STORMWATER DRAIN #417 to serve BROOKFIELD ADDITION - PHASE I CITY OF WICHITA, KANSAS

Gary Janzen, P.E. City Engineer
Project Number 468 - 85177
OCA Number 751555

AS BUILT PLANS

Contractor: Unruh Excavating
Inspector: David VanSickle, Baughman Co.
As Builts by: KEK, 2/21/18

Baughman Brookfield Addition - Phase I
LINE 3
 Storm Water Drain Improvements

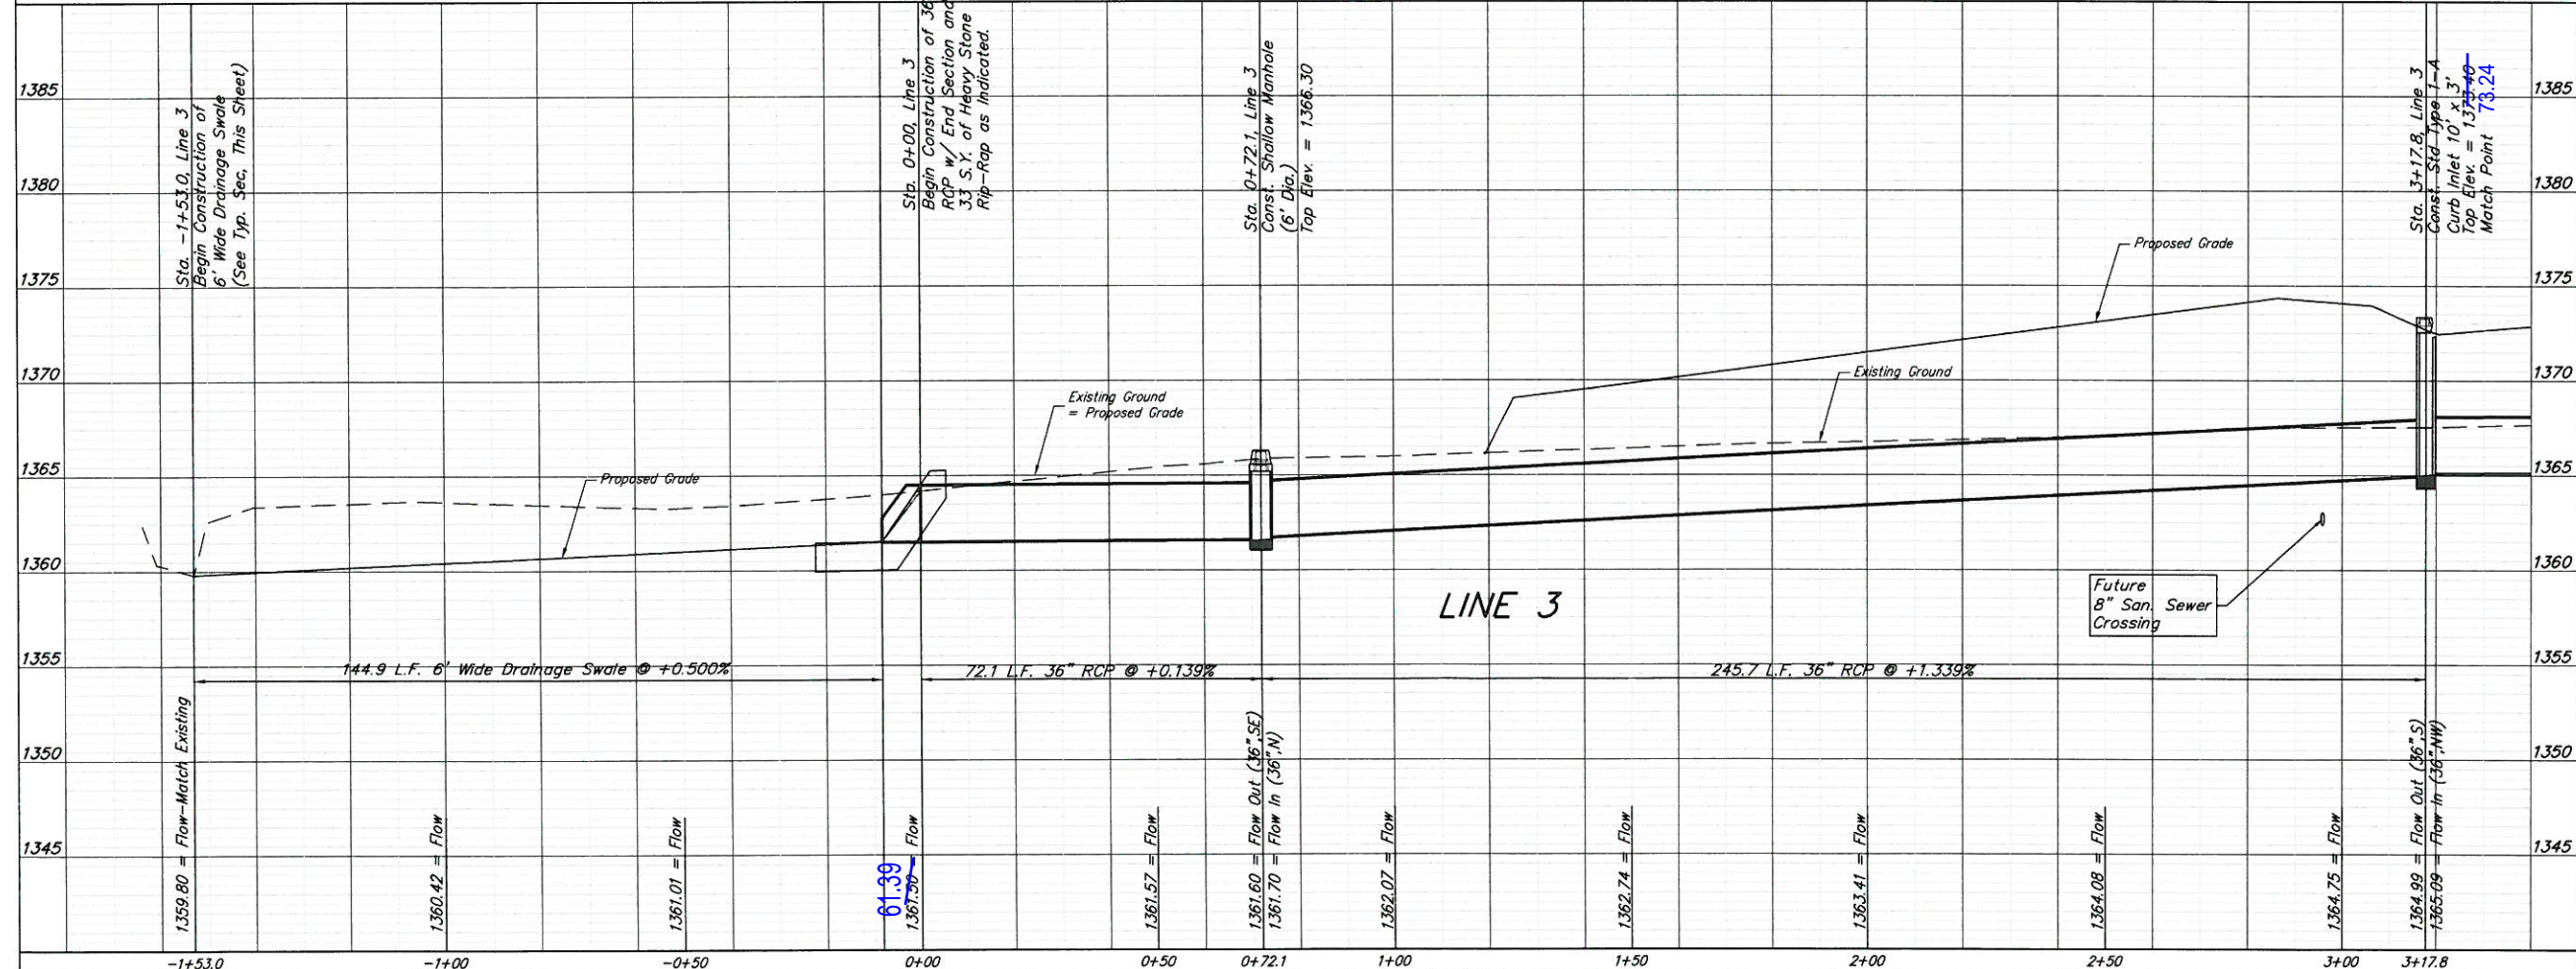
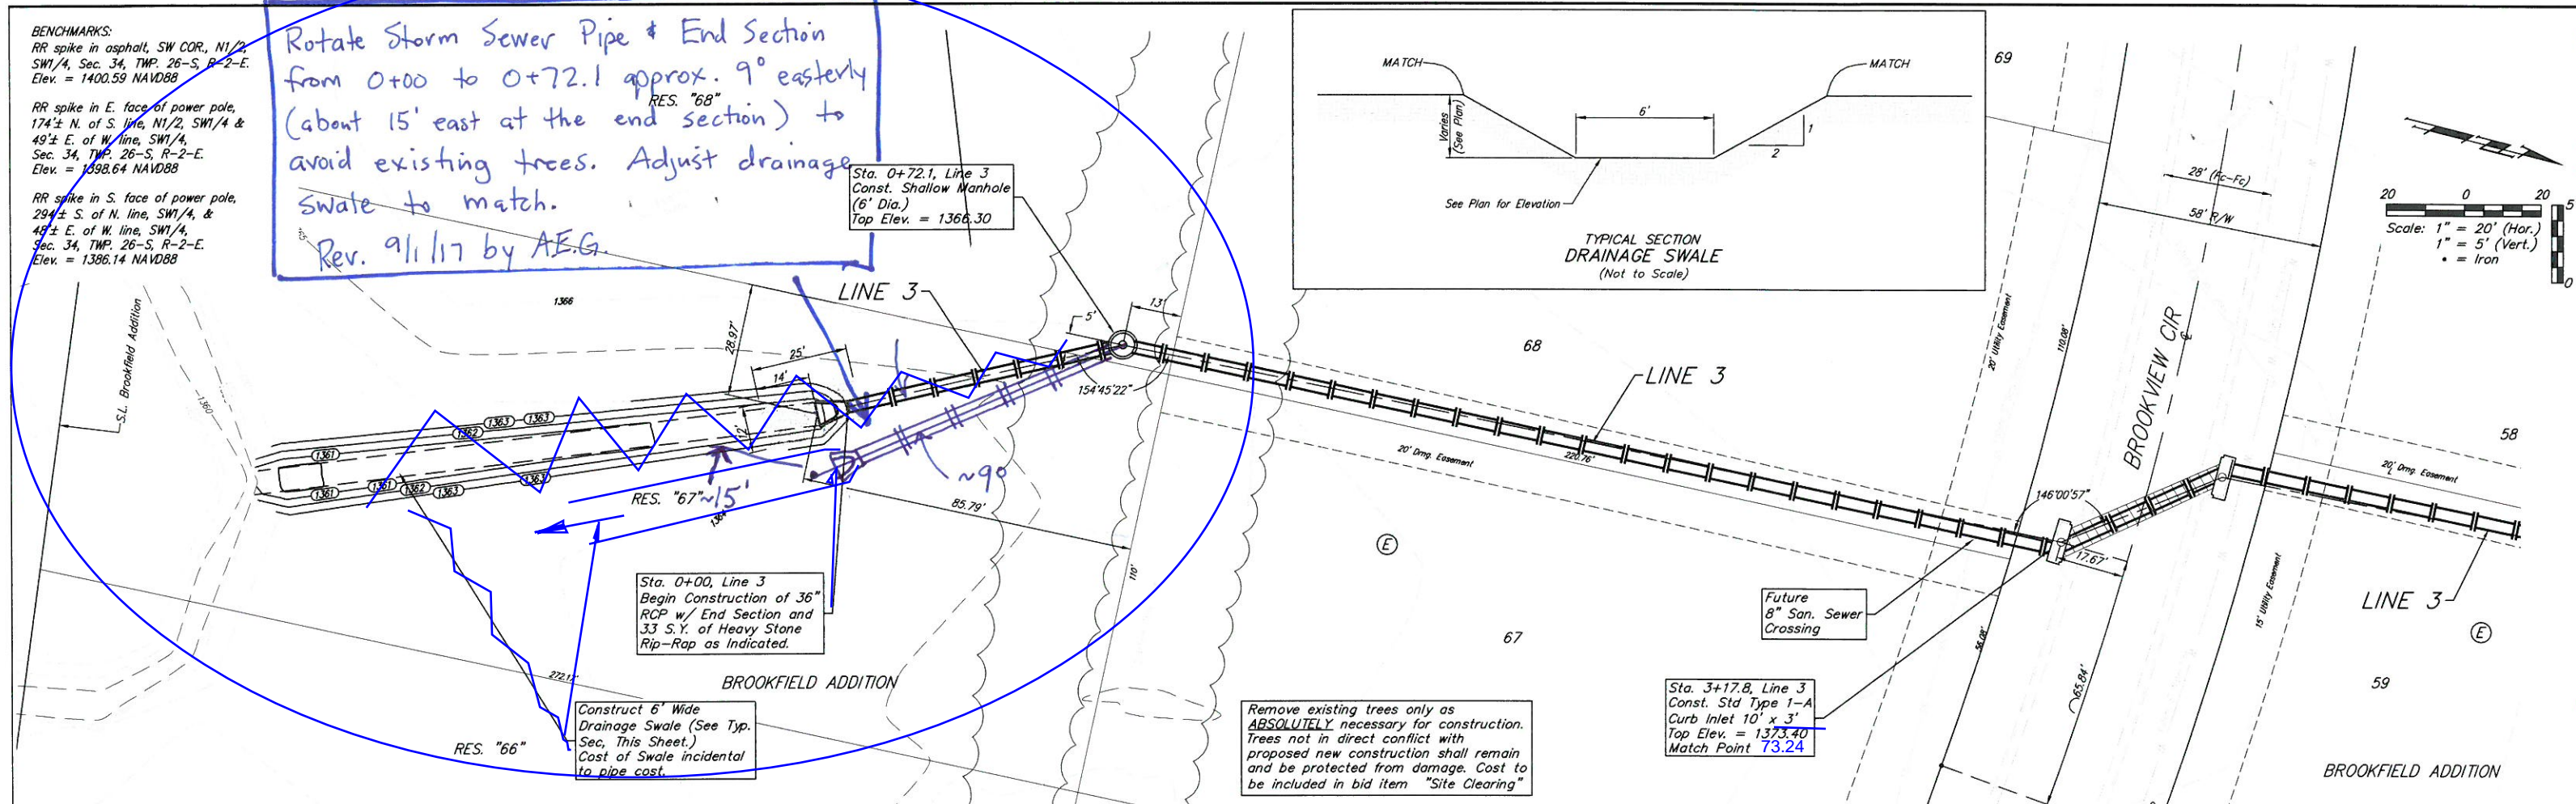
Rotate Storm Sewer Pipe & End Section from 0+00 to 0+72.1 approx. 9° easterly (about 15' east at the end section) to avoid existing trees. Adjust drainage swale to match.
 Rev. 9/1/17 by AEG.
